## **NRC Staff Compiled Comments on Industry CASS Screening Position**

#### NRC Staff Response to Industry Comments on Staff Position Dated 7-10-14

Figure 1 - NUREG/CR-4513 Lower Bound J-R Curves for 10-15% Ferrite Showing Margin Above 255 kJ/m<sup>2</sup> at 2.5 mm for CF-3 and CF-8

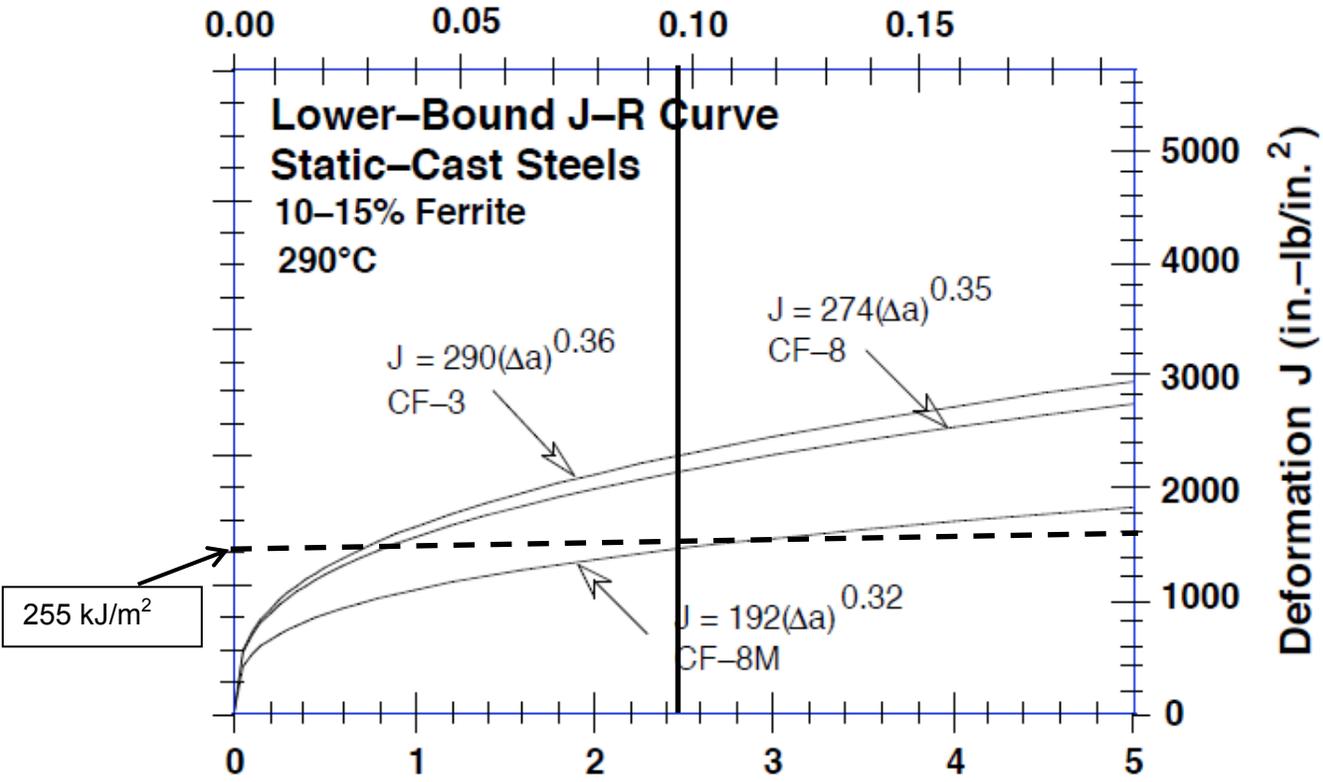
The “NRC staff’s position” section also notes that the staff applies criteria to two different ferrite screening levels depending on neutron “exposure”. The staff suggests changing the ferrite screening to the levels described in NUREG/CR-4513, Rev. 1 (10% and 15% ferrite) from the current ferrite screening levels (14% and 20%) accepted both by the staff and industry for license renewal (e.g., the Grimes letter, MRP-175, and MRP-227-A) without a described technical basis. The basis data for the 14% and 20% screening levels of ferrite are established in industry documentation that clearly states the conservatism used in determining these values and thus it is not clear why additional conservatism (i.e., decreasing the ferrite screening levels to 10% and 15%) is required.

- Basis for Reduced Ferrite Screening Levels at > 0.45 dpa
  - NRC reduced ferrite content
    - Accounts for uncertainty of end state toughness due to IE+TE
    - NUREG/CR-4513 J-R curves for TE alone show significant margin above 255 kJ/m<sup>2</sup> at 2.5 mm crack extension at:
      - 10-15% ferrite for low-moly
      - <10% ferrite for high-moly
  - This provides margin for uncertainty wrt additional embrittlement due to fluence

See Figure 1 below for an illustration of the principle. The figure shows there is considerable margin for the lower bound curves for CF-3 and CF-8 above the 255 kJ/m<sup>2</sup> toughness level at

2.5 mm crack extension. However, for the CF-8M with the same ferrite range, the toughness is right around 255 kJ/m<sup>2</sup>. Therefore, for the CF-8M there is no additional margin for reductions in toughness due to irradiation effects. Figure 2 shows a similar plot for <10 ferrite, which shows even CF-8M has some margin of toughness above 255 kJ/m<sup>2</sup> at 2.5 mm crack extension.
